Project	<b>IEEE 802.16 Broadband Wireless Access Working Group</b> < <a href="http://ieee802.org/16">http://ieee802.org/16</a> >	
Title	<b>Fixes for Network Entry Flow Charts</b>	
Date Submitted	<b>2006-09-22</b>	
Source(s)	Nadav Lavi et al Alvarion Ltd. [Address Line 1] [Address Line 2]	Voice: +97236457834 Fax: [Fax Number] <a href="mailto:Nadav.lavi@alvarion.com">[mailto:Nadav.lavi@alvarion.com]</a>
Re:		
Abstract	Fixes for Network Entry Flow Charts in 802.16e	
Purpose	For the review in 802.16 Maint TG	
Notice	This document has been prepared to assist IEEE 802.16. It is offered as a basis for discussion and is not binding on the contributing individual(s) or organization(s). The material in this document is subject to change in form and content after further study. The contributor(s) reserve(s) the right to add, amend or withdraw material contained herein.	
Release	The contributor grants a free, irrevocable license to the IEEE to incorporate material contained in this contribution, and any modifications thereof, in the creation of an IEEE Standards publication; to copyright in the IEEE's name any IEEE Standards publication even though it may include portions of this contribution;

Figure 67-Handling SBC-REQ

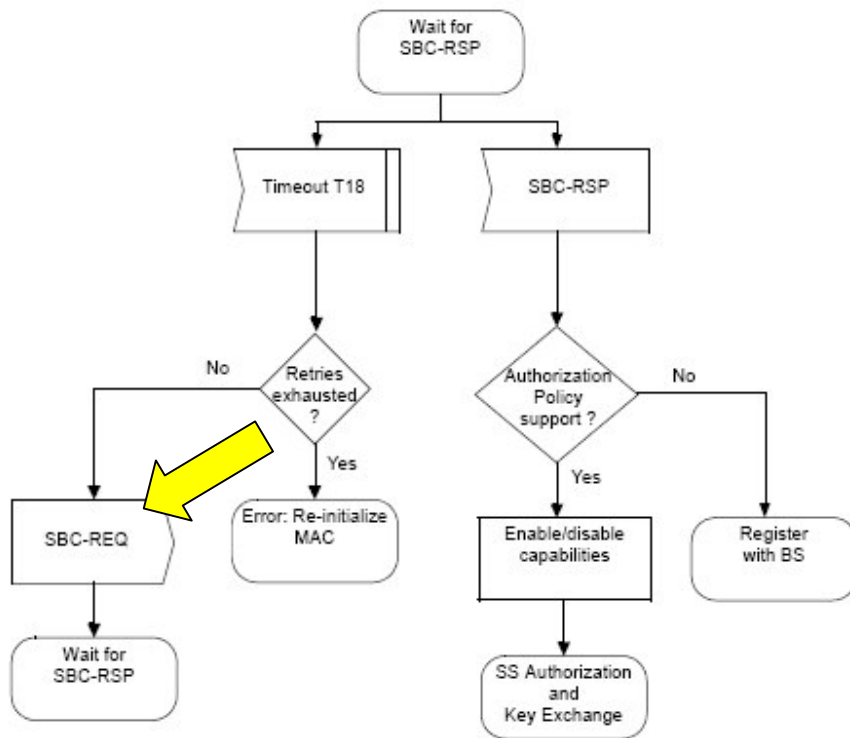
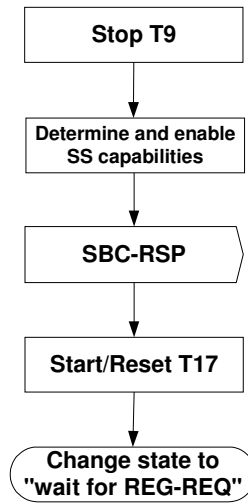
1. There is an unclear definition of how to handle expiration of T9 in the BS side in SBC transaction, and expiration of T17 in the BS side in REG transaction. The condition for “Release and age-out connections” is unclear and not well defined. In addition, this action is local to the BS and thus remains unknown to the MS. We suggest that the BS would send unsolicited RNG-RSP message with Abort instruction when these timers expire.
2. The current Network Entry flow chart cannot handle retransmission, either due to processing delays or message drop. After the BS transmits a response message, it will proceed directly to the next state in the Network Entry flow and thus cannot handle a retransmission of request by the MS; this would cause the Network Entry procedure to end in failure. For example, the following flow chart (Figure 67 in 802.16e-2005) shows that BS sends SBC-RSP.

However after sending SBC-RSP, the BS proceeds directly to the registration step. The corresponding flow chart (Figure 70) does not contain any state where a retransmission of SBC-REQ can be received and processed. This is just an example of one single scenario. Similar failures can be identified for other steps in the entire Network Entry flow.

Replace Figure 67 in 6.3.9.7 with the following figure:

Figure 68 – Registration – SS

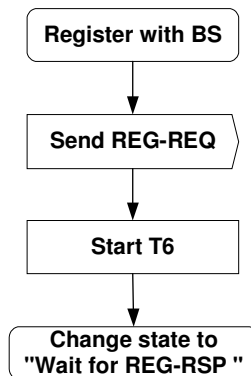
Replace Figure 68 in 6.3.9.9 with the following figure:

Figure 66 – Handling SBC-RSP

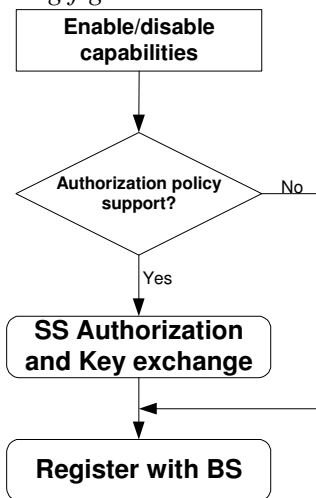
If the MS does not receive SBC-RSP within T18 timeout, it will retransmit the SBC-REQ (Figure 66).

Replace Figure 66 in 6.3.9.7 with the following figure:

Figure X – Network entry state-machine BS side.

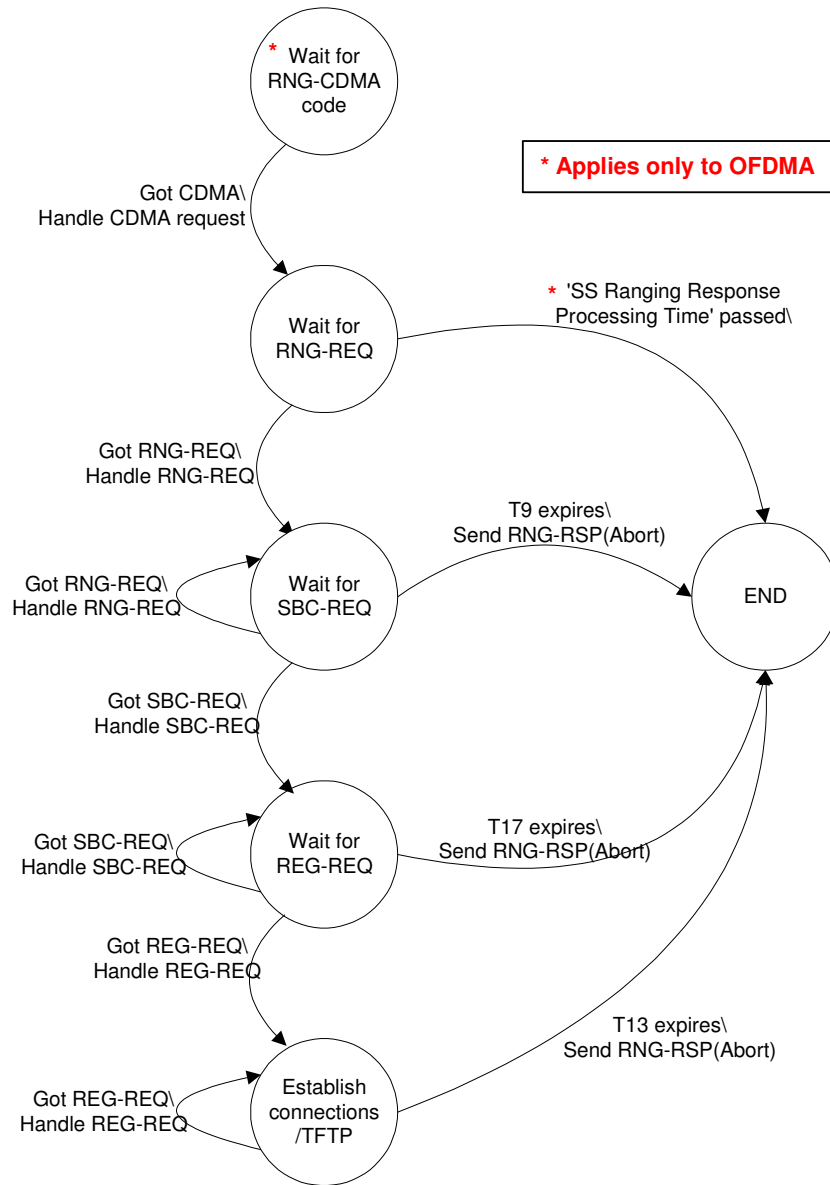
We suggest the Network Entry process be specified using 1) Network Entry state machine, and 2) set of actions/procedures of handling the Network Entry messages. This will provide a clearer definition of the network entry procedure as well as the handling of error/failure conditions.

Add the following Figure:
